Groundwater Application Review Summary Form

Application # G- 19355

PUBLIC INTEREST REVIEW FOR GROUNDWATER APPLICATIONS

TO: Water Rights Section Date 6/5/2023
 FROM: Groundwater Section Grayson Fish
 Reviewer's Name
 SUBJECT: Application G- 19355 Supersedes review of _____
 Date of Review(s)

Water-Level Measurements in Nearby Wells

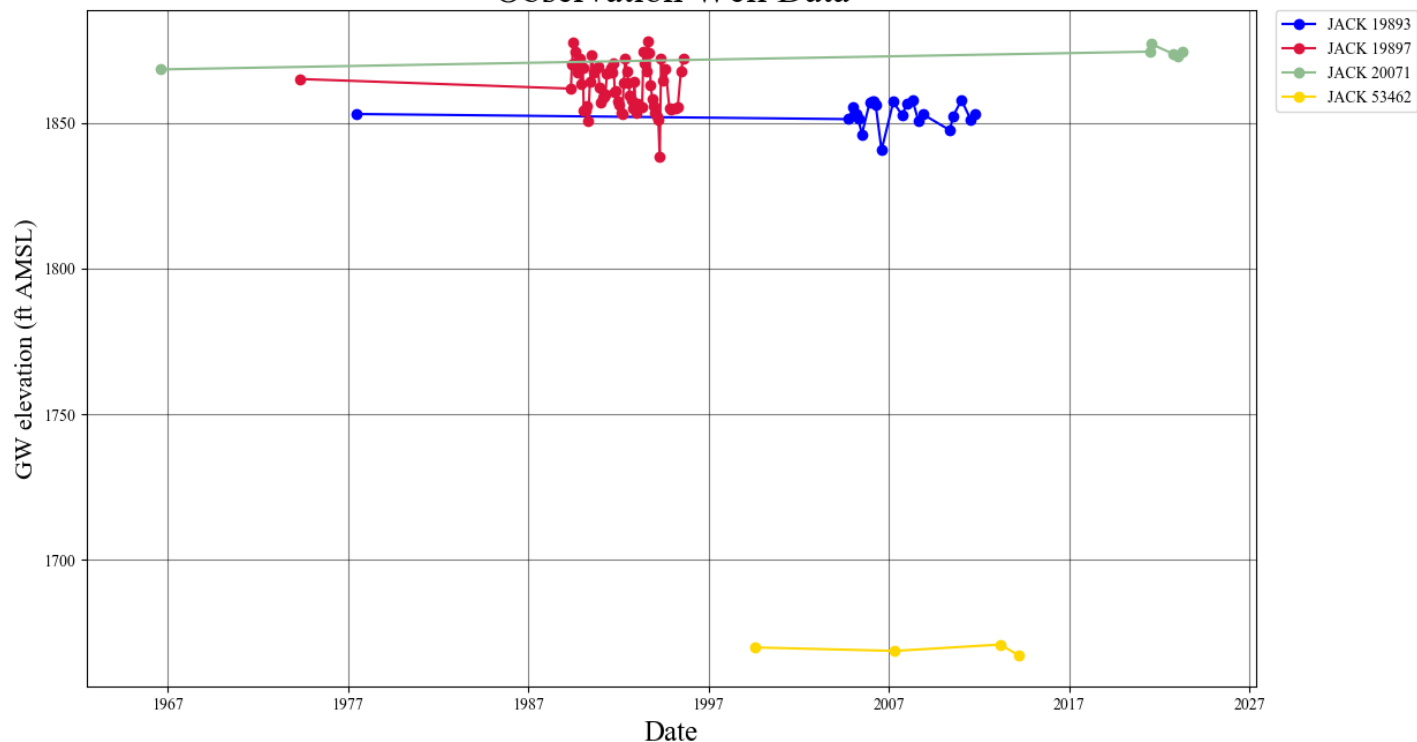
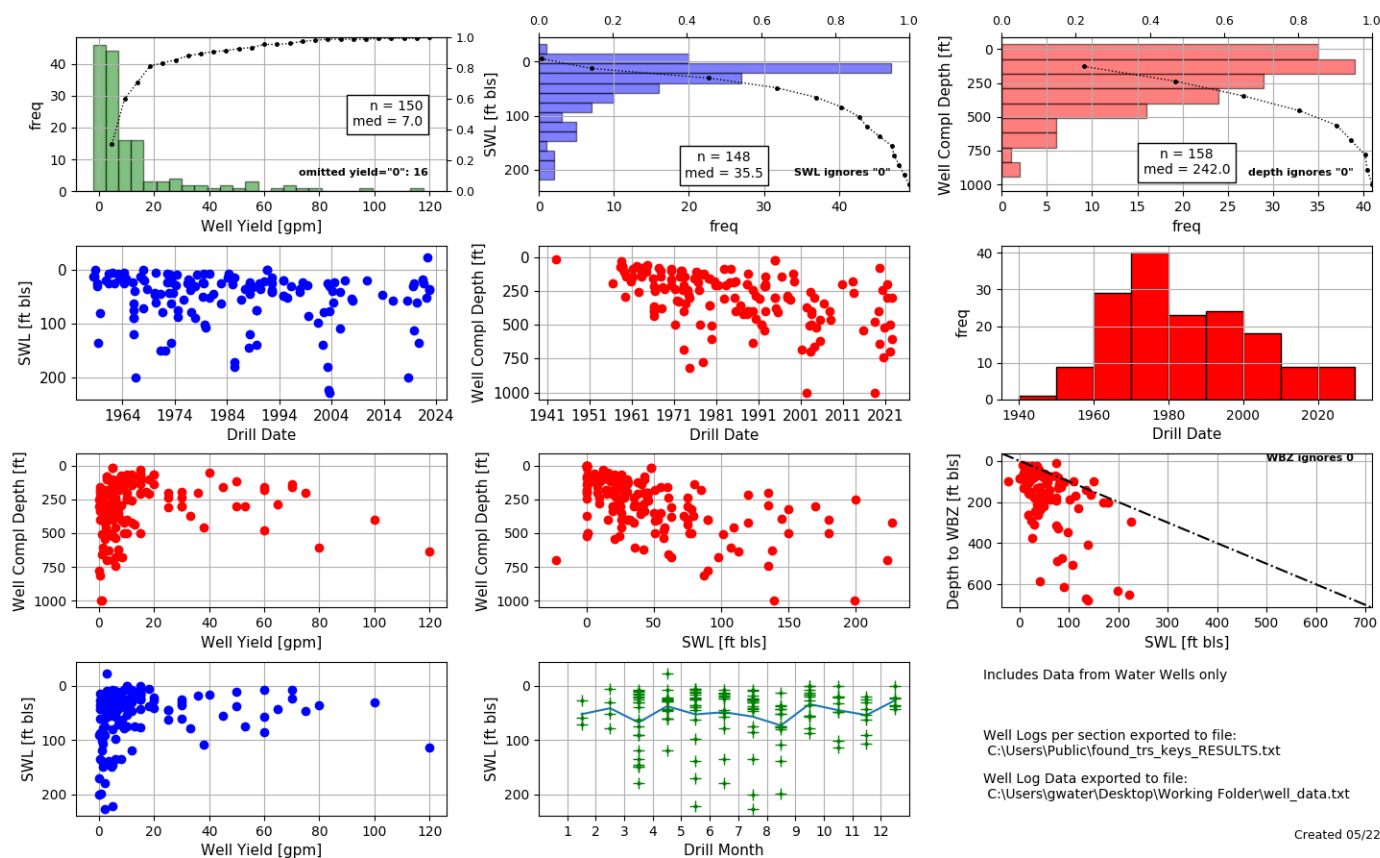
- B3. **Groundwater availability remarks:** The applicants proposed well will likely source water from an aquifer within fractures and jointing of the Hornbrook Formation at the foot of the Payne Cliffs physiographic feature (Wiley et. al., 2011). Median well yields for wells located in TRS 38S/1W-S11, 12, 13 and 14 are 7 gpm. Some deeper wells report water bearing zones producing greater than 20 gpm. The closest observation well (JACK 53462) is located approximately 1 ¼ miles northwest of the proposed POA and has a limited water level record. Water levels of other wells within the Bear Creek Valley reflect topography and appear relatively stable with time. As the observed groundwater level trends in nearby wells do not meet the definition excessively declined or excessively declining per OAR 690-008-001 (4) and (6), groundwater does not appear to be over-appropriated.

Theis Distance Drawdown Modeling

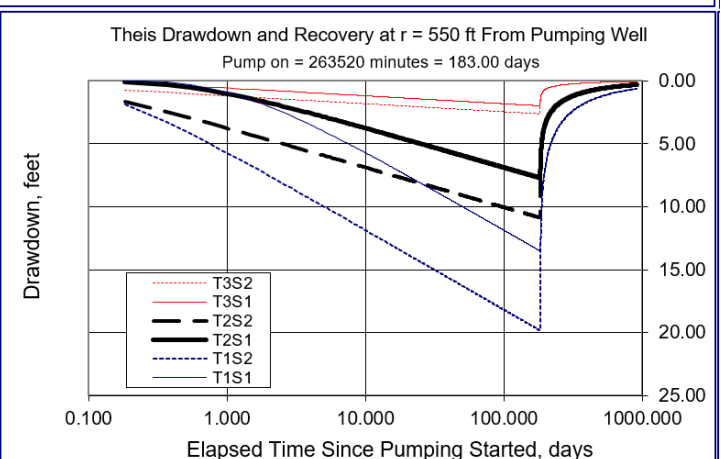
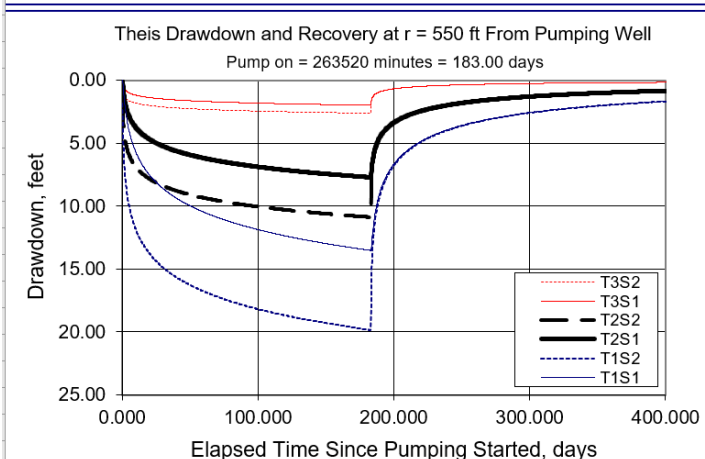
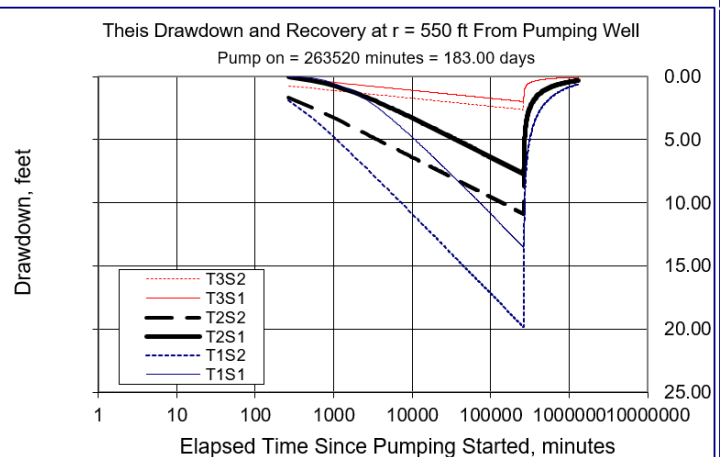
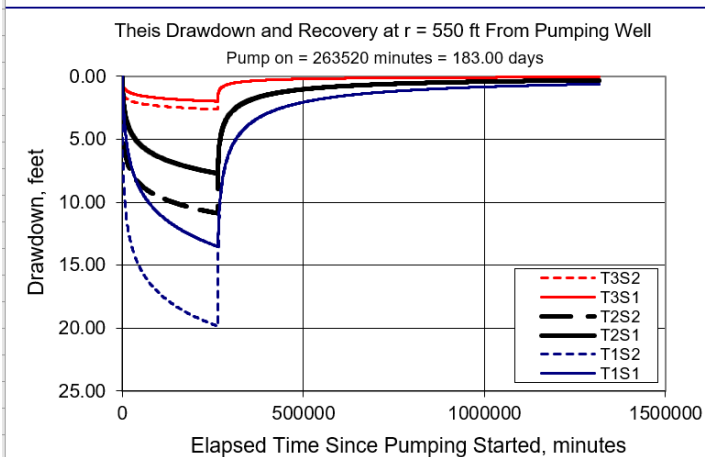
The closest groundwater uses to the applicant's proposed POA are likely exempt use wells on nearby tax lots for domestic purposes. Adjacent tax lots range from 550 to 1300 feet from the proposed POA. A Theis distance drawdown model was used to estimate the magnitude of well-to-well interference that may result from the proposed use (Theis 1935). Results indicate that this use could produce 2 to 20 feet of drawdown in nearby wells, however, given the uncertainty inherent with using analytical models to predict the occurrence and magnitude of drawdown in fractured bedrock aquifers, a preponderance of evidence does not exist to determine injury is likely to occur. Similarly, a POD associated with a spring under Certificate 15497 is located approximately 3000 feet to the Southeast of the proposed POA on Kenutchen Creek. Given the distance of the mapped spring from the proposed POA and the expected drawdown, a preponderance of evidence does not exist to determine injury is likely to occur. Permit conditions should be applied as referenced in B1(d)(i) of this review form.

Model parameters are estimates of bulk aquifer properties in the Hornbrook Formation based on published values for flow in fractured sedimentary aquifers.

- i. ☒ The permit should contain condition #(s) 7-C, 7-J, Medium-use reporting;
 - ii. ☐ The permit should be conditioned as indicated in item 2 below.
